## Updates to Increase Top Speed

<b>Classification</b>	Repair Bulletin	<b>Section/Group</b>	40 - Rear Drive Unit	<b>Country/Region</b>	All
<b>Year</b>	2014-2015	<b>Model</b>	Model S	<b>Version</b>	85, P85D

This Service Bulletin supersedes SB-15-40-001, dated 19-May-15. Each content change is marked by a vertical line in the left margin. Discard the previous version and replace it with this one.

**Figure 1 (Revision level highlighted)**

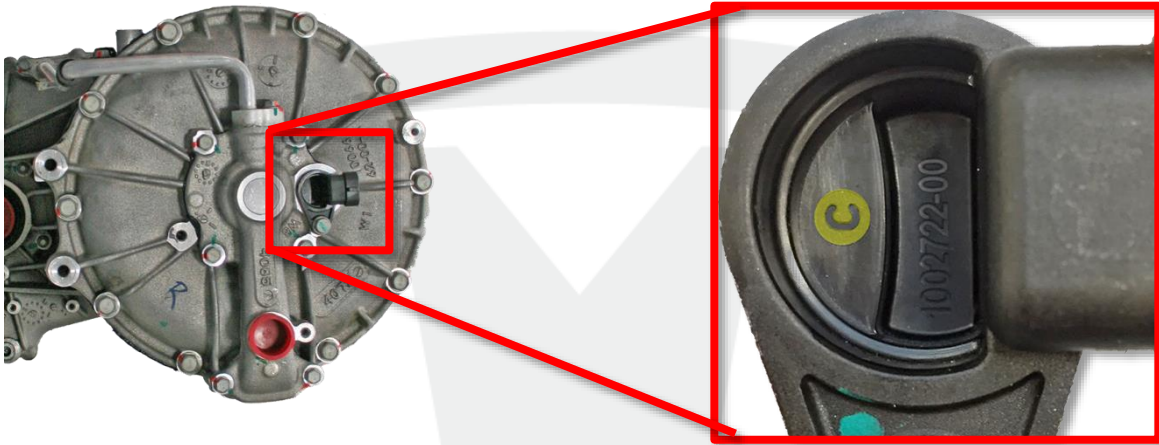
1. Remove the mid aero shield (refer to Service Manual procedure 12030502).
2. Use a mirror or borescope to check the part number on the rear drive unit motor speed sensor (Figure 1).
  - If the part number is 1002722-00-B, replace the speed sensor with revision C or later (refer to Service Manual procedure 40102002), then continue to step 3.
  - If the part number is 1002722-00-C or later, continue to step 3.
